PLANNING COMMISSION STAFF REPORT

Meeting Date: January 20, 2026

RE: Truckee Railyard Hotel (Planning Application #2024-00000086; 10108 Truckee Way; APN 019-421-001)

Figure 8: Streetscape Plan

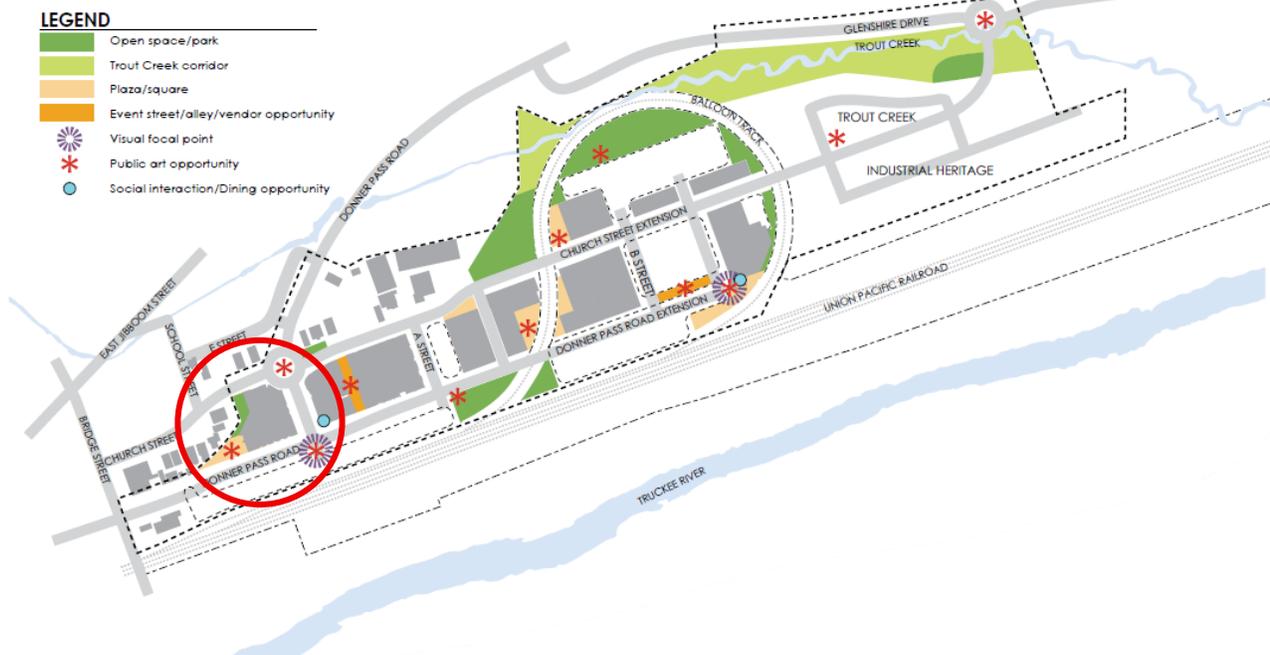
The Streetscape Plan identifies the southwestern corner of the project site property for a plaza/square with public art and open space/park near the rock (see Figure 8). Staff recommended that the applicant “Consider a pedestrian walkway from the plaza through the site to Church Street, by the rock. The walkway could be open only during business hours to manage use of the area. This walkway would be more consistent with the intent of the Streetscape Plan. Additionally, consider how public art could be accommodated in this space in the future. While not required, you may also want to consider if public art could be accommodated in or near the mechanical yard on the northeast corner of the building.”

Figure 9: Site Plan

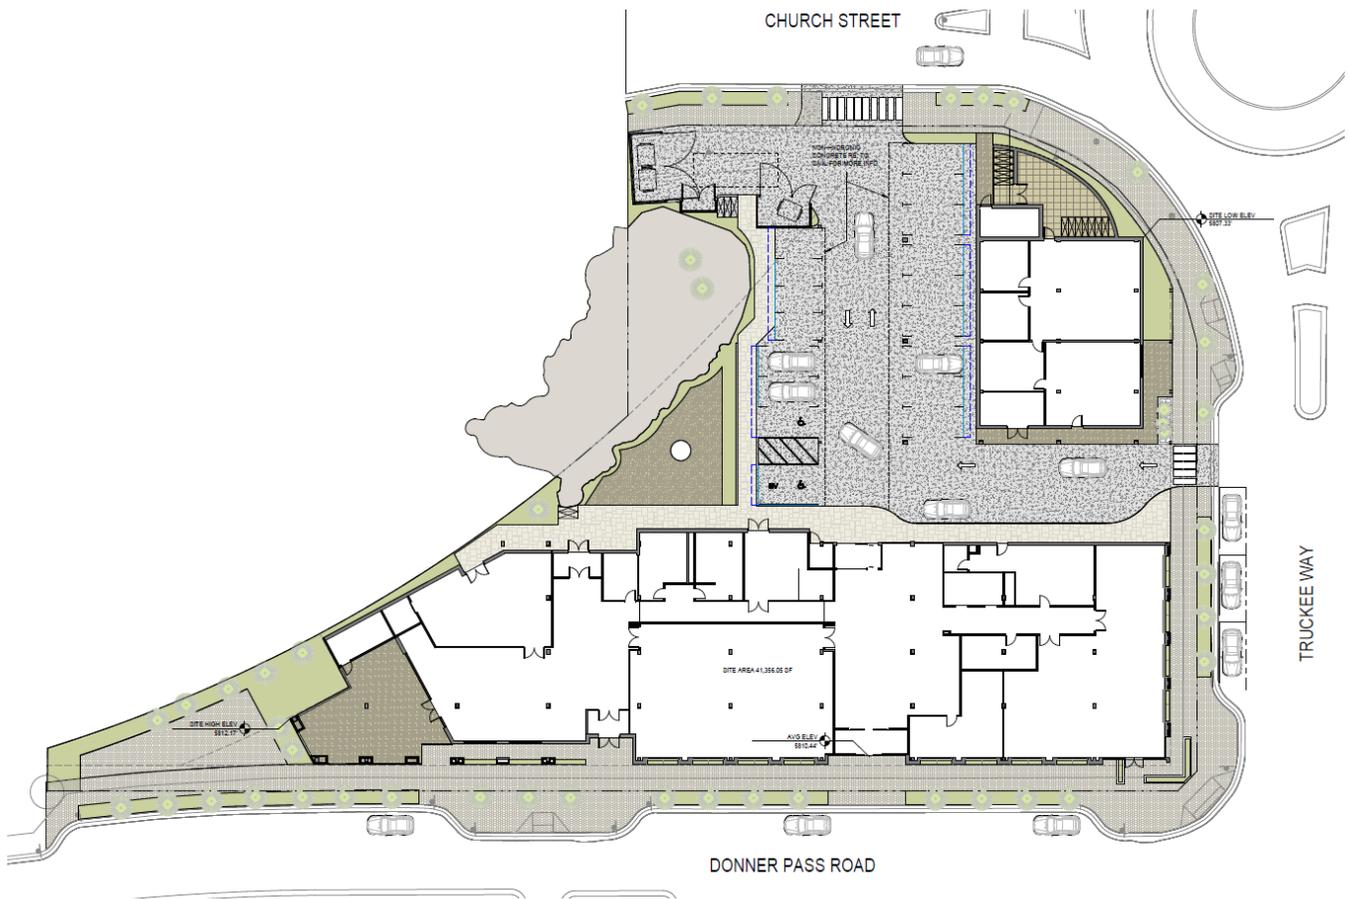
The applicant reviewed staff's recommendation and stated that “[g]iven the overall constraints of the site and development code requirements (including, but not limited to, trash, onsite parking, snow removal, landscaping and location of the existing rock formation), a pedestrian walkway from the plaza through the site to Church Street is not feasible without materially diminishing anticipated uses/density, site operability, and the overall value of the site to the broader Railyard. In particular, great effort was made to create a north-south walkway adjacent to the rock connecting the trash facilities and delivery zone to a main entrance of the Project. This walkway is critical to operational flow and must be available for use by Project employs and guests at all necessary times. Allowing pedestrian use of this walkway would severely impact the Project.” See Figure 9 for proposed site plan.

The Planning Commission may wish to consider if a condition should be applied that requires access from the outdoor plaza to the rock, if public access to the rock through the restaurant or hotel lobby, or if allowing public access to the rock from Church Street would be appropriate. If public access from the outdoor plaza to the rock is applied, modification to the site plan would be required. Other than this open space and access to the rock, staff believes the project is consistent with the Streetscape Plan.

Figure 10: Roof Plan with Roof Appurtenances Highlighted

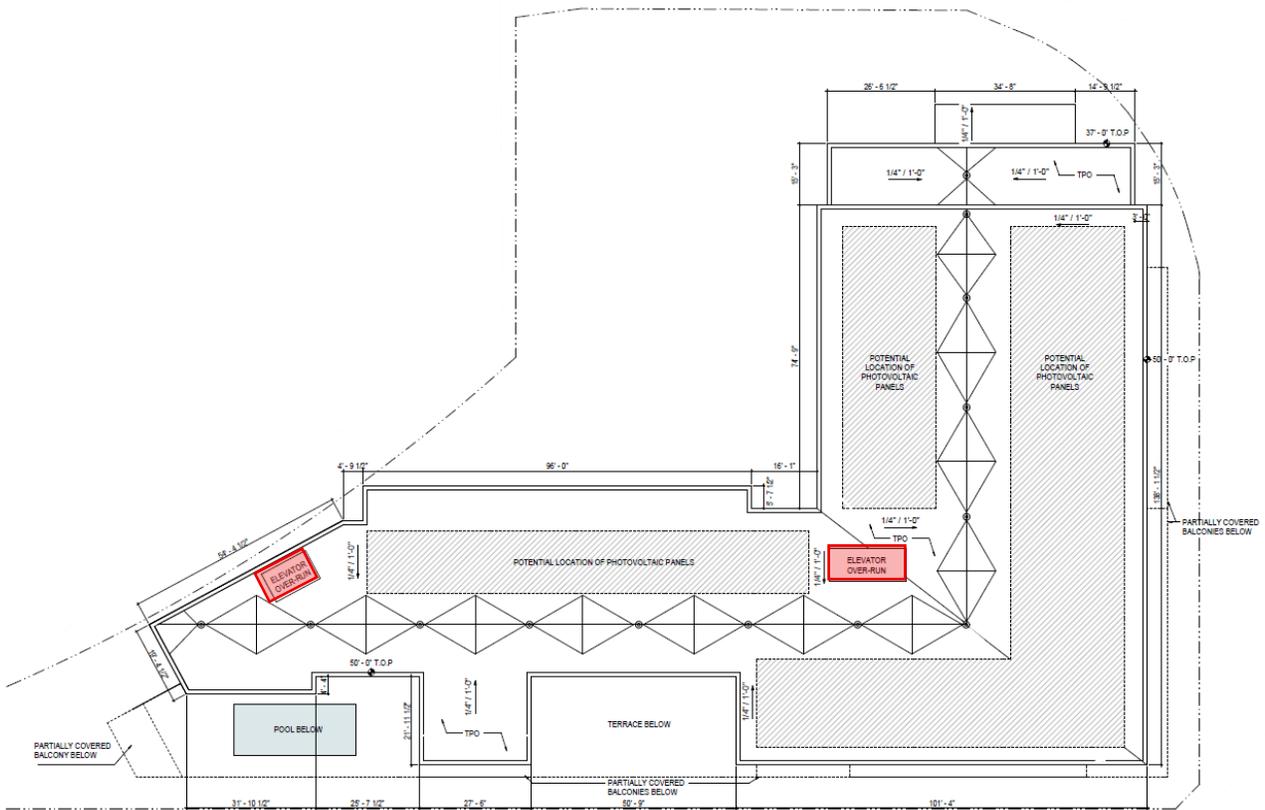
The western elevator is located approximately 50.5 feet from the front edge of the roof and the eastern elevator is located approximately 55.5 feet from the front of the roof. The eastern elevator is also located approximately 64 feet from the edge of the roofline on the eastern side, along Truckee Way. The western elevator is located on the far western side of the building.

Figure 12: Sight Lines for the Mechanical Appurtenances

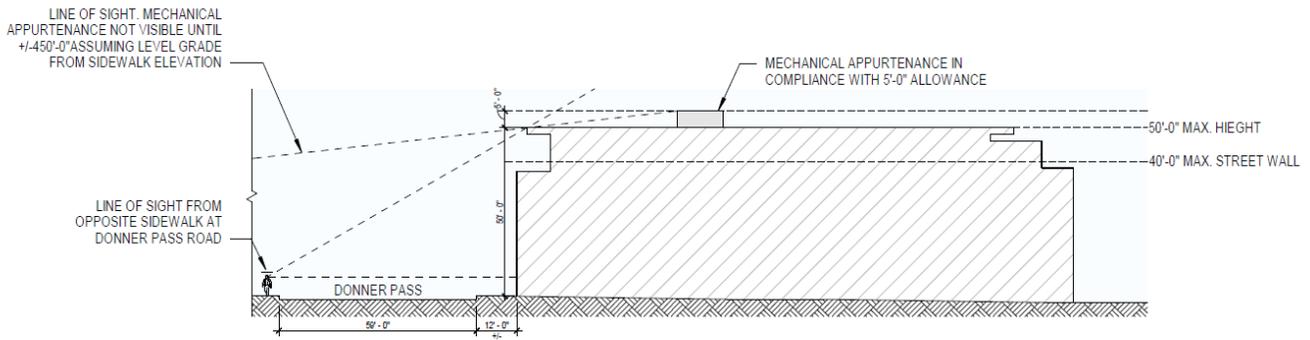
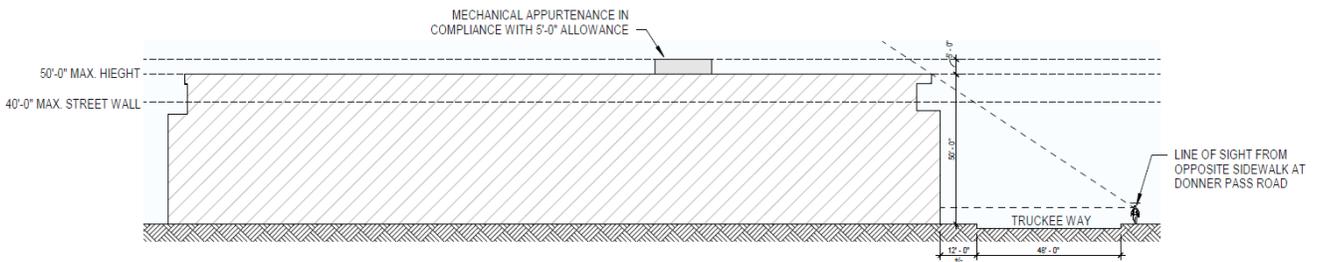
The applicant states that the eastern elevator would not be visible until approximately 450 feet from the sidewalk elevation south of the building (See Figure 12). While the line-of-sight study was not completed to the east or for the western elevator, staff believes that the finding would be similar. The elevator overruns would likely only be visible from very far away or from higher floors on surrounding buildings. Staff believes that the increase in height is minor in nature and does not detrimentally impact the design of the structure.
